# SERVICE BULLETIN

## 4-1/4", 9:1 Basic Oil Piston Pumps MODELS EFFECTED: 662409, 662410-B and 662420-B

RELEASED: 3-12-09  
REVISED:  
(REV. 01)  
BULLETIN: #1-09

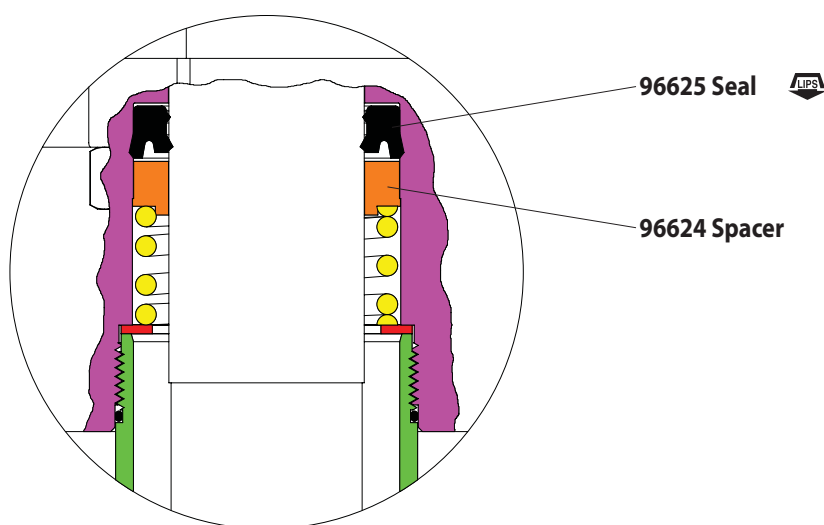
1. 77327 female packing washer replaced with 96625 seal.
2. Remove (4) 90578-4 "V" packings.
3. 91349 male packing washer replaced with 96624 spacer.
4. This change effects models built beginning March 13, 2009 (S/N C0139XXX).
